NORTH DISTRICT DEVELOPMENT PLAN

PROJECT # 958080

Final Environmental Impact Report

2.0 REVISIONS TO THE REVISED DRAFT EIR

FIGURE 3.0-7

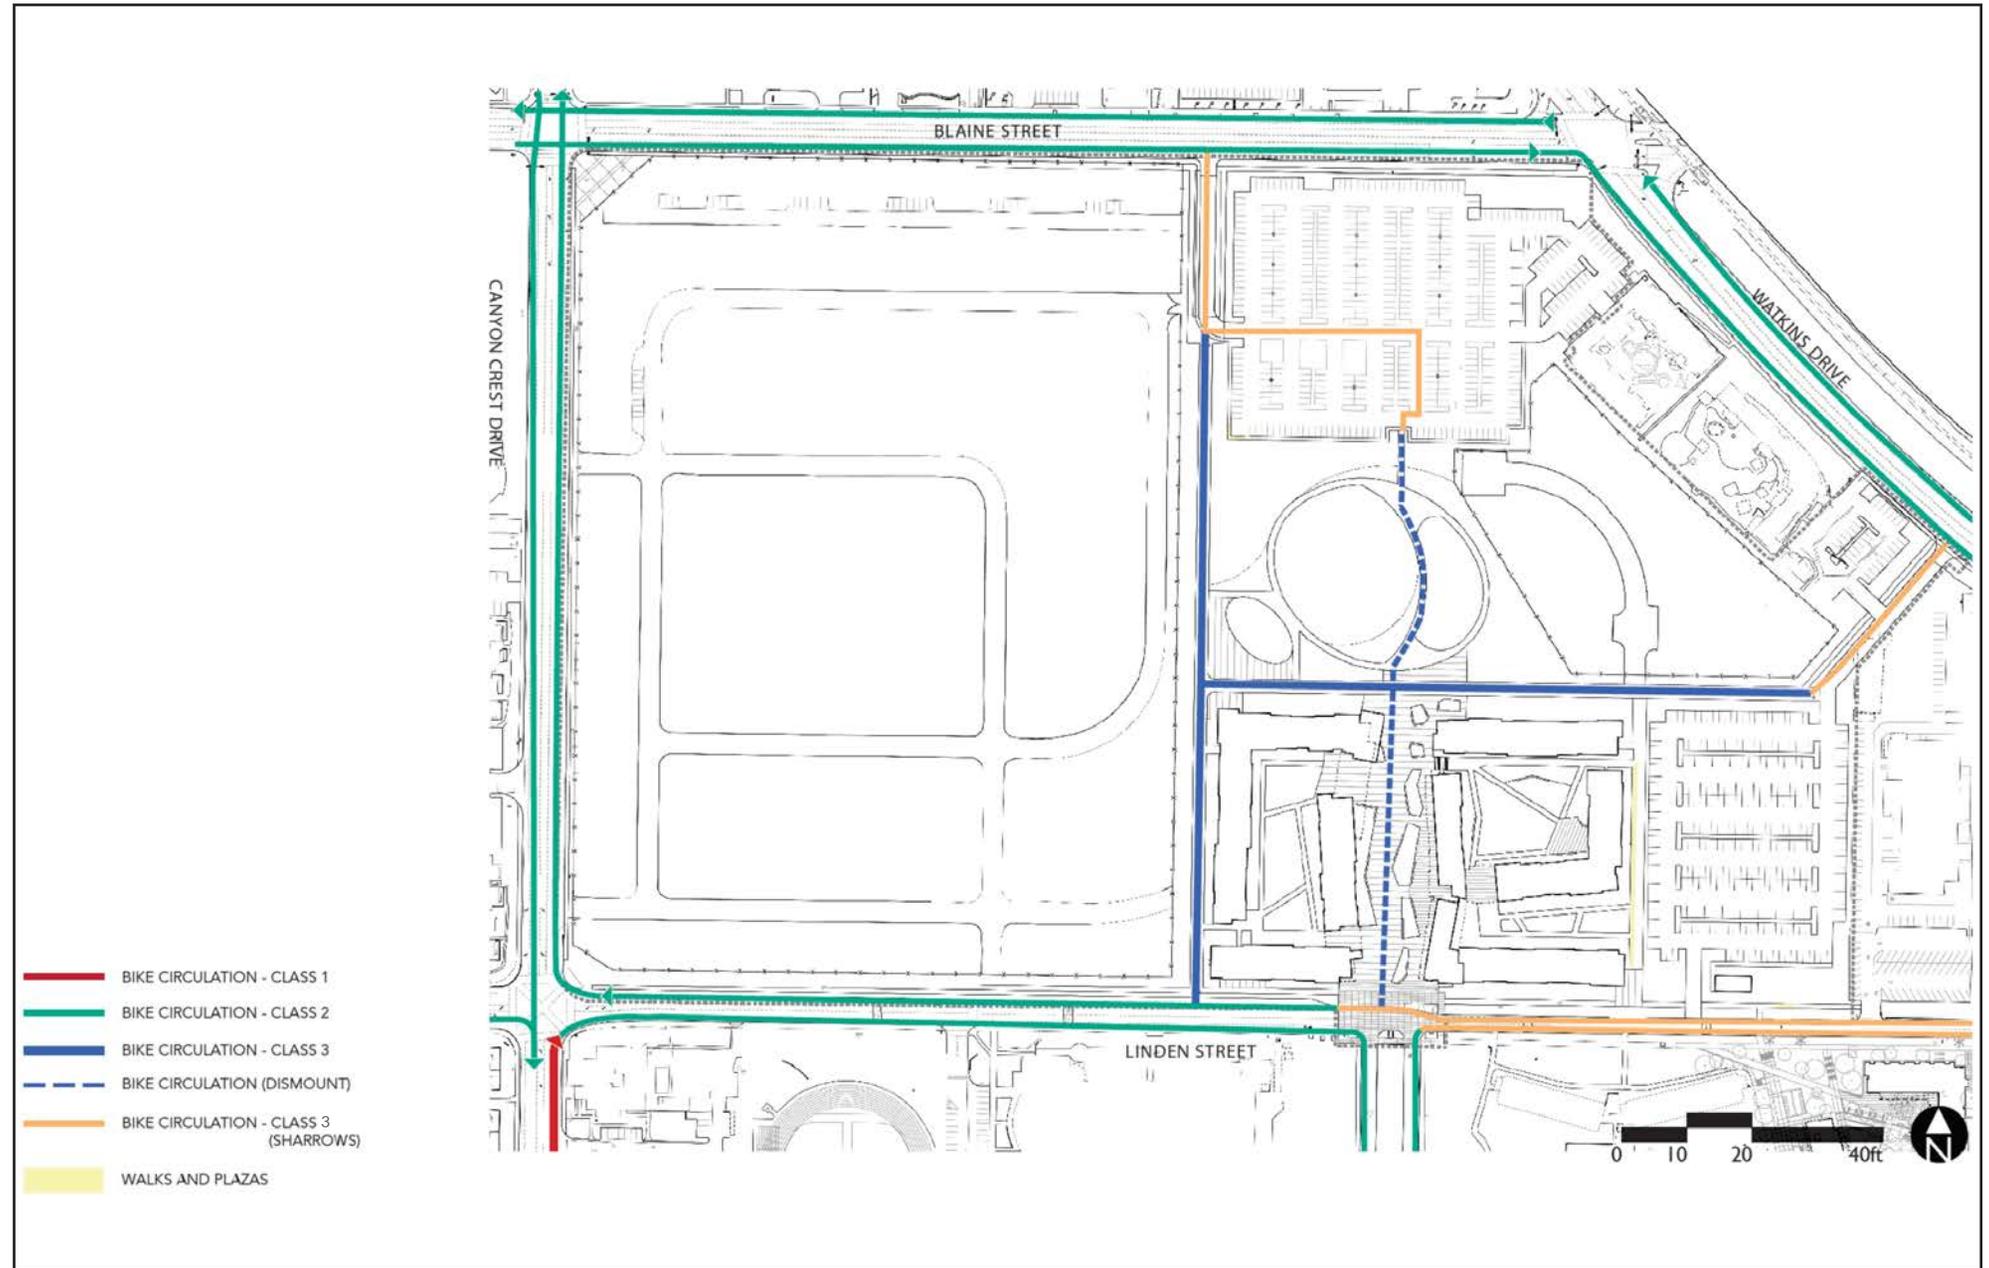
- The Public Works Department has reviewed the Traffic Impact Study included in the Revised DEIR, and has the following comments:
 1. As discussed between the UCR Campus Planning team and the City of Riverside on April 15, 2019, please provide additional details regarding the development and inclusion of cumulative project vehicular trips in the Traffic Impact Analysis.
 2. Figure 5 (North District Development Plan - Multi-Modal Routes) identifies sharrows as Class 4 bicycle lane. As per established bikeway classifications, a lane marked with a sharrow is a Class 3 bicycle lanes.

Figure 3.0-7 on page 3.0-20 has been revised to show the correct bicycle facility classifications.

Figure 3.0-7, North District Development Plan – Phase 1 – Multi-Modal Routes has been updated to correct the bicycle facility classifications. Please refer to Section 2.0, Revisions to the Revised Draft EIR.
